*				
1.	GENI	GENERAL INFORMATION (originally approved document)				
	a.	Reevaluation Phase: Design Change				
	b.	Document Type and Date of Approval: <u>EA/FONSI approved January 25, 19</u> (please see attached signed <u>EA/FONSI cover page and study corridor Figure 1</u>

C.	Project Numbers: 14504-1601 RS-7810(4) 7125920 State Project Federal Aid Work Program No.				
	d. Project Local Name, Location, and Limits: SR 54 (now SR 56) in Pasco County, Florida. From Cypress Creek to the Zephyrhills East Bypass, a distance of approximately 14 miles.

c. Segments of Highway Being Advanced: <u>SR 56 from Meadow Pointe Boulevard</u> to US 301, a distance of approximately 6.0 miles. Please see the attached segment location map, Figure 2.

V. EVALUATION OF MAJOR DESIGN CHANGES (e.g., Typical Section Changes, Alignment Shifts, Right of Way (ROW) Changes, Bridge to Box Culvert, and Drainage Requirements).

FIGURE 3

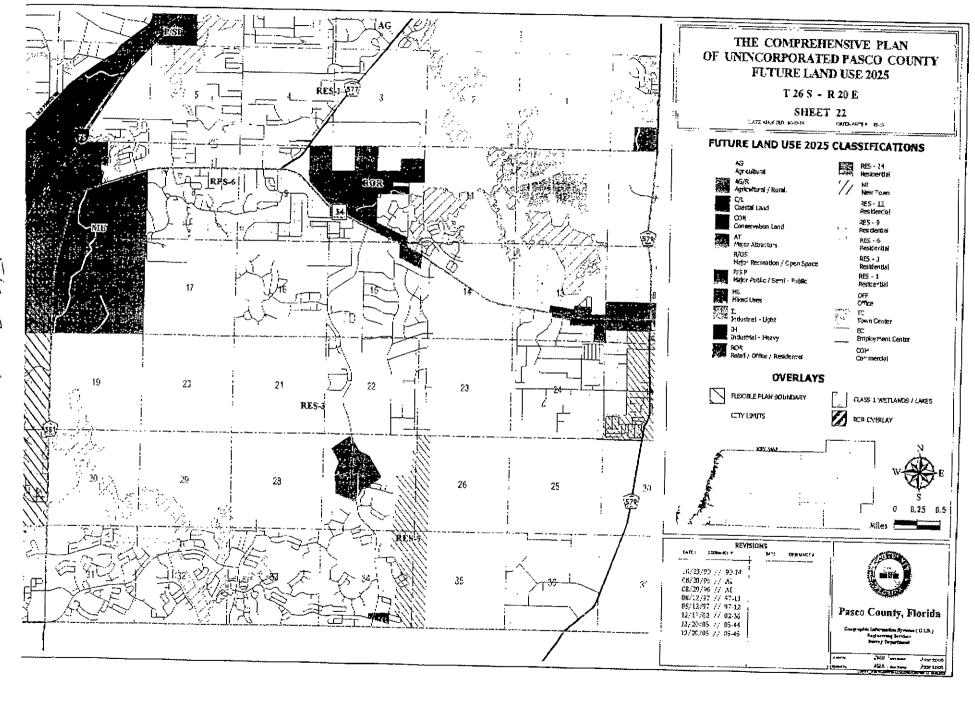
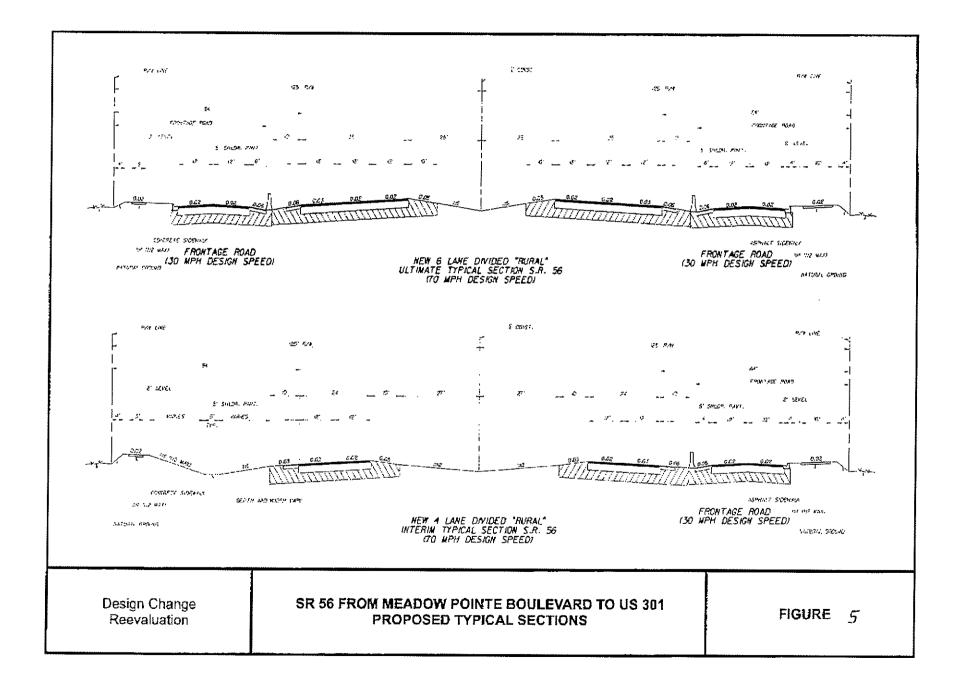
The current proposed design for the segment of SR 56 from Meadow Pointe Boulevard to US 301 includes an alignment shift to the south from just east of Meadow Pointe Boulevard to the intersection of US 301. A map of the study area is provided (see Figure 2). The proposed shift in alignment compared to the previously approved concept is shown in Figure 3. This planned alignment shift does not have any involvement with any adjacent public parks. This clarification is being made as previous coordination with the FHWA indicated that the planned shift of the original SR 56 alignment would encroach into a Pasco County Park. As noted on the attached Pasco County correspondence that included their Land Use Map (Figure 4), there are no Pasco County designated public park properties within the vicinity of the planned realignment.

The original PD&E Study did not include a detailed stormwater management plan. The design proposes the use of twelve pond sites that have been identified with the aid of the developers along the SR 56 corridor and their respective proposed DRIs. The proposed pond sites are identified in Figure 3. Right-of-way for the proposed ponds will be acquired according to federal and state regulations. All of the proposed pond sites are sufficient in size to handle the stormwater management requirements for this segment of SR 56.
